Staff Report

To: Salt Lake City Planning Commission
From: J.P. Goates, 801-535-7236, jp.goates@slcgov.com
Date: April 7, 2016
Re: PLNSUB2016-00060 – Redwood Landing Industrial Park

Planned Development

PROPERTY ADDRESS: 954 S Redwood Road
PARCEL ID: 15-10-177-001, 15-10-177-006, 15-10-177-002, 15-10-177-007, 15-10-177-008
MASTER PLAN: Westside
ZONING DISTRICT: CC Corridor Commercial and M-1 Light Manufacturing

REDWOOD DEPOT PLAT 1

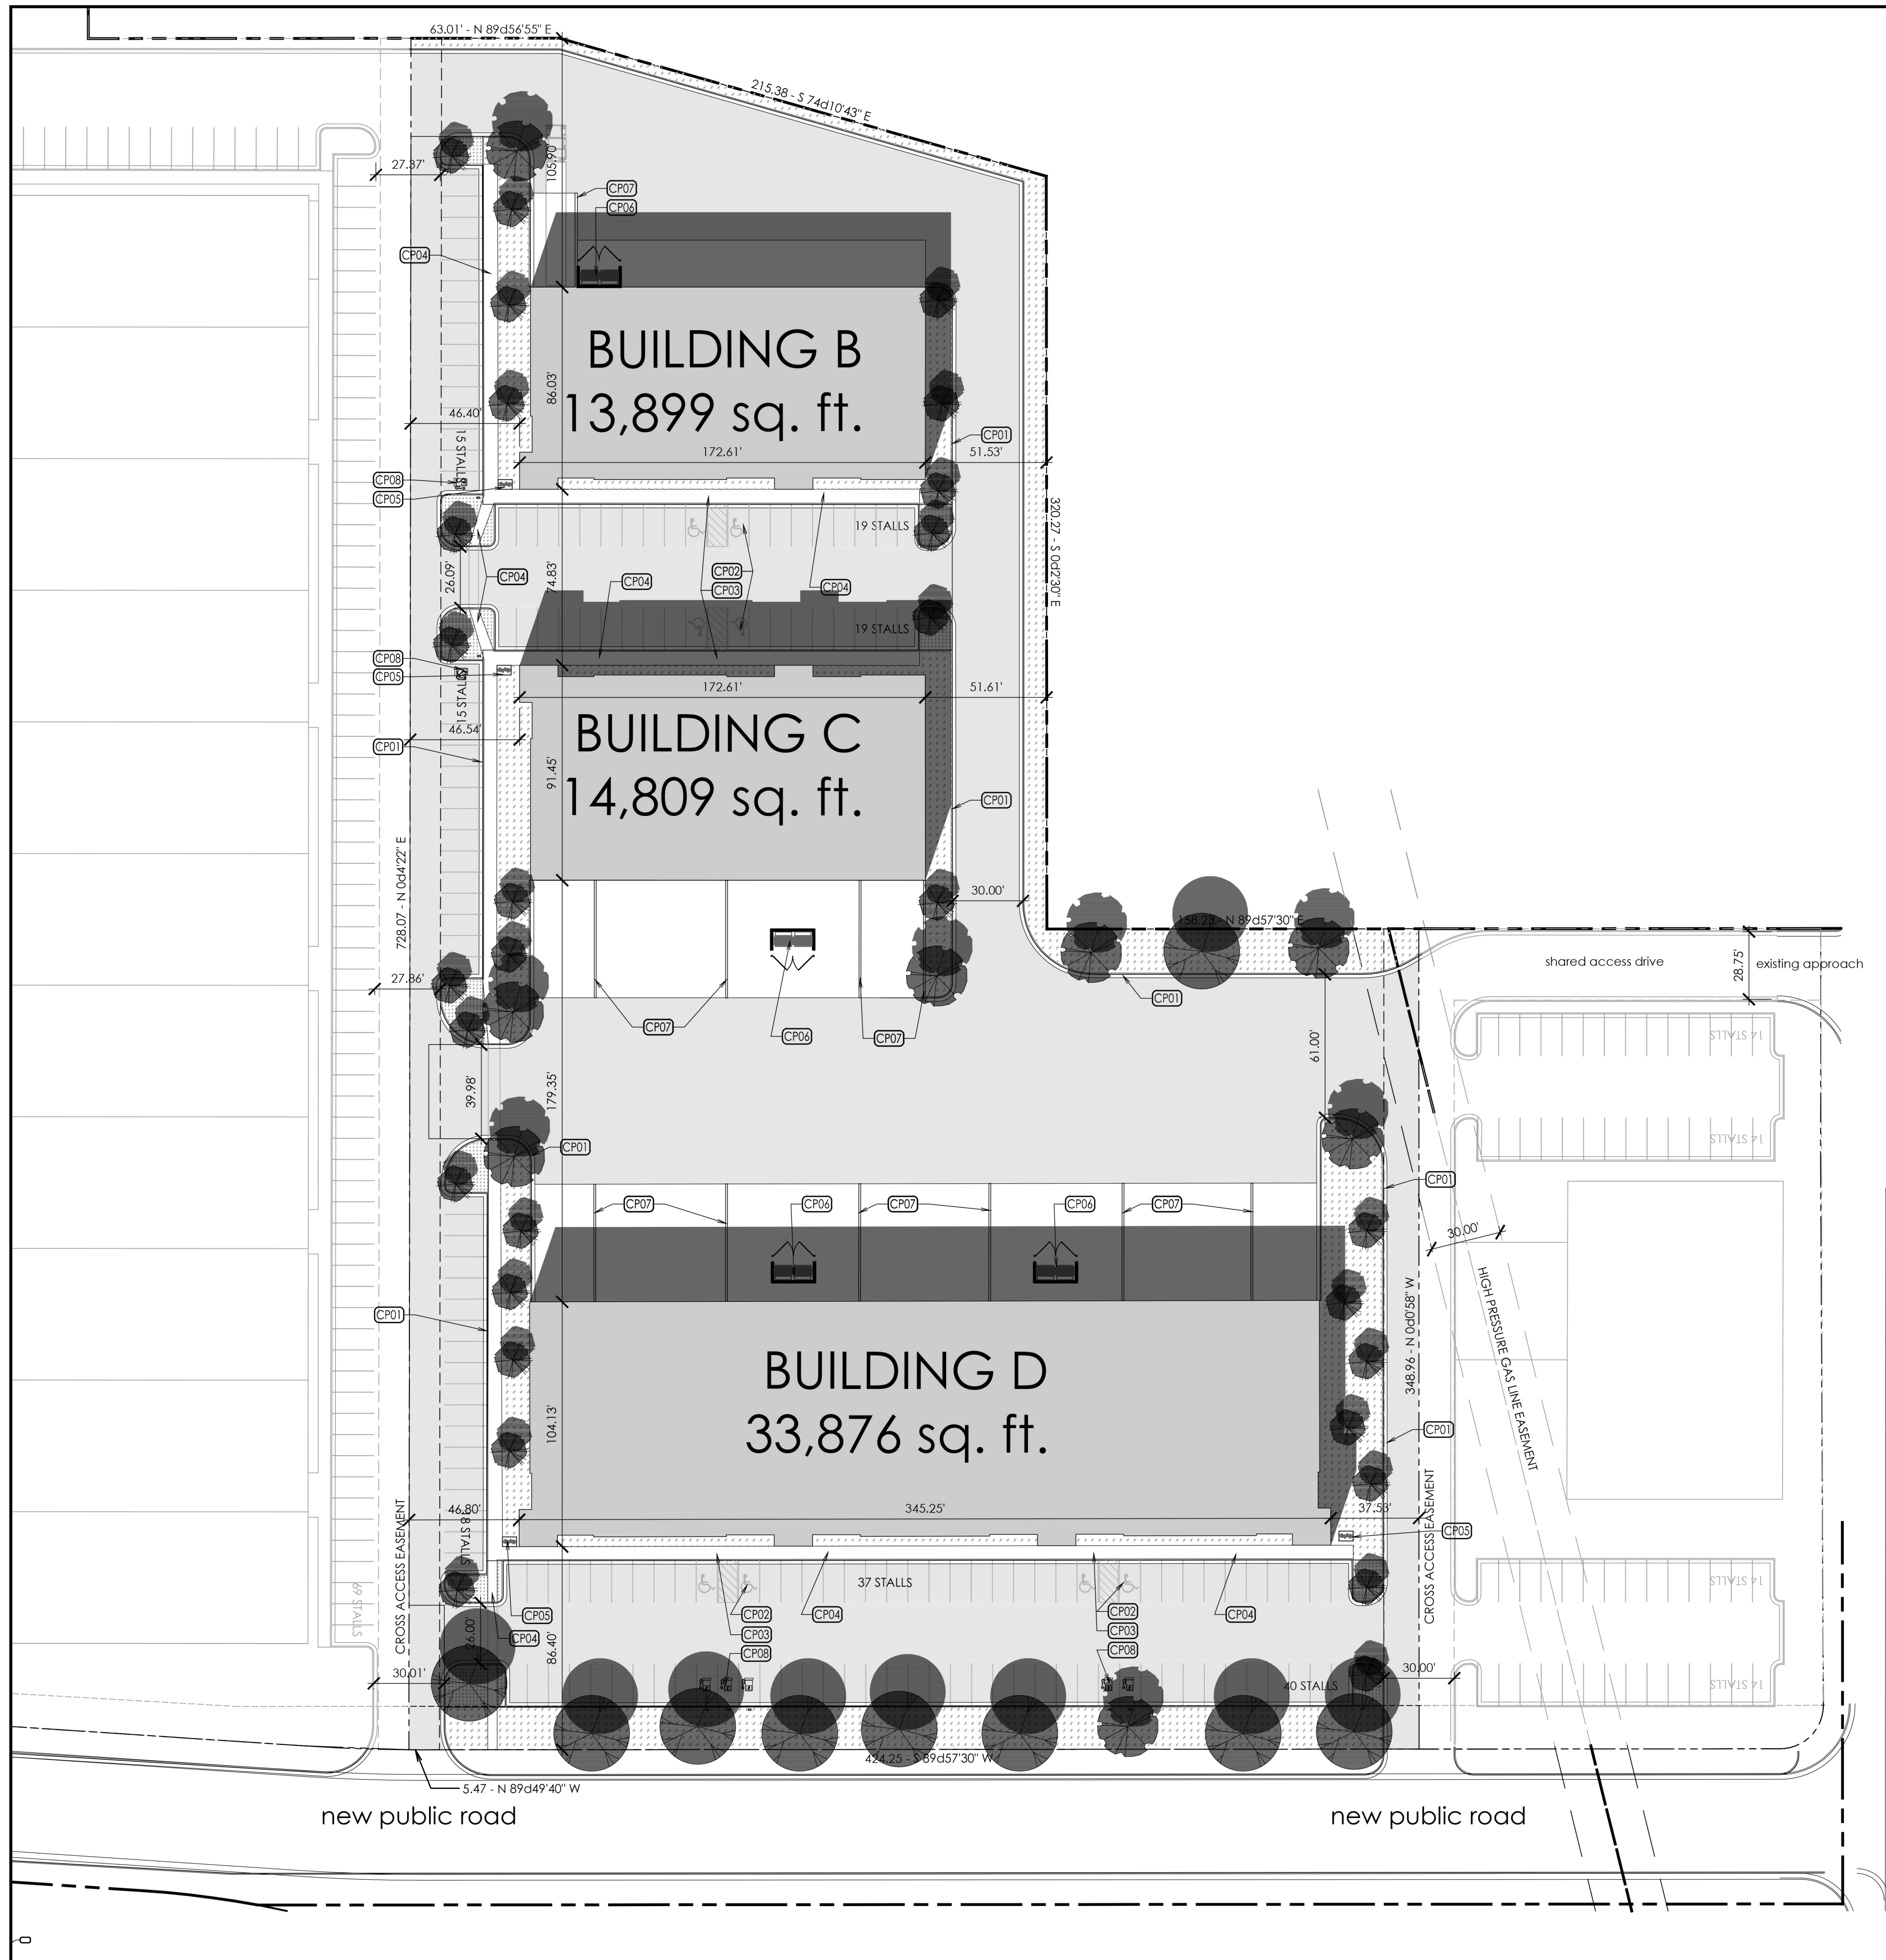
- 4) The plat uploaded to the building permit application does not match the final plat submitted to planning division. Please upload a copy of the final Redwood Landing Business Center Plat 1 to p-dox. The final plat and planned development approval from planning is required prior to permit issuance. For information contact Jonathan Goates at 801-535-7236.

AE2015.033
SITE PLAN

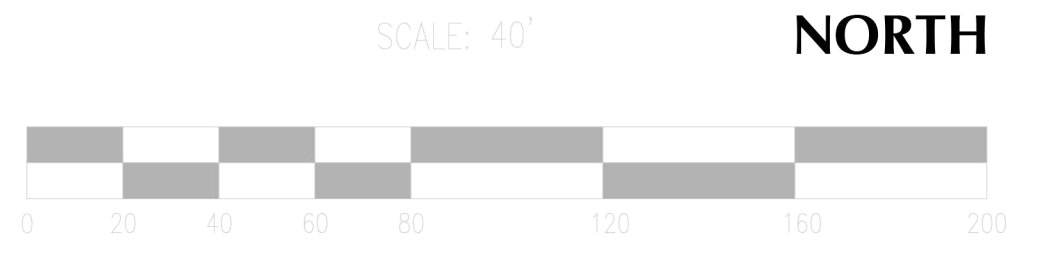
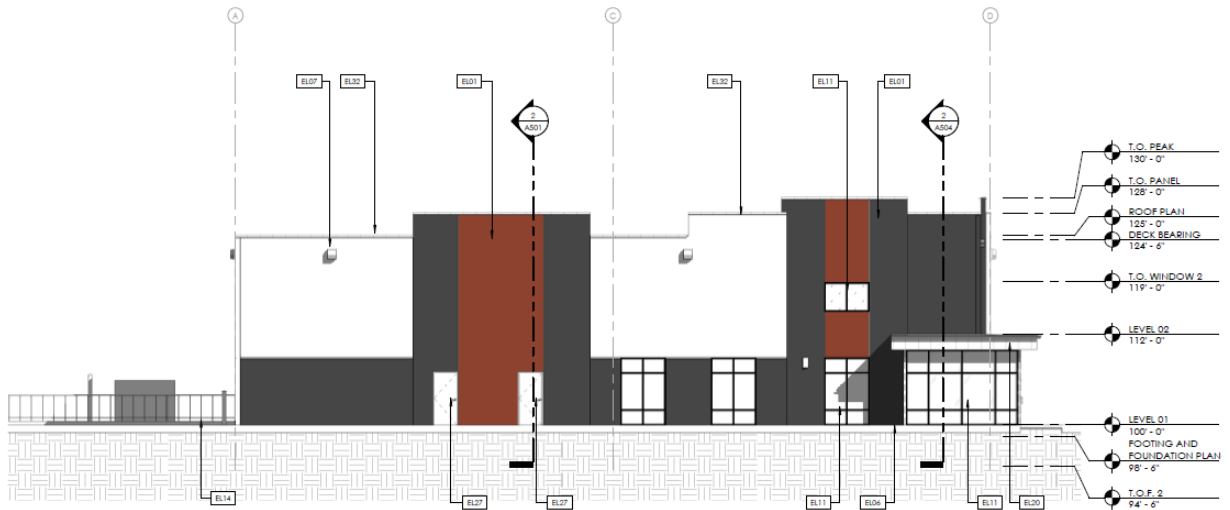
- 5) Please provide property line dimensions on the architectural site plan and civil site plan for review against the final plat.
- 6) A minimum 15 feet landscape setback is required along Redwood Depot Lane. Please provide setback dimensions on the civil and architectural site plans.

- 7) Review your minimum required, and total provided, parking calculations on the architectural site plan and civil site plan and make them match. Document your calculations so I know how you are arriving at your numbers for required parking. For example, 62,584 square feet of warehouse space requires 33 stalls, rather than 136 stalls. Parking calculations shall be provided for each principal building and/or use. What about office space?

- 8) As per 21A.44.050.B.2, electric vehicle parking stalls shall be located as close to the primary building entrance as possible.
- 9) On the electrical plans provide details and specifications for the electric vehicle charging stations that comply with NEC Article 625.

- 11) The landscape plan requires the following corrections or additional information:
 - A seven feet wide perimeter parking lot landscape setback is required with trees and shrubs as per 21A.48.070.C, wherever parking lots are located closer than 20 feet to a property line. The planned development review will need to address the lack of perimeter parking lot landscaping along the west property line abutting lot 3.
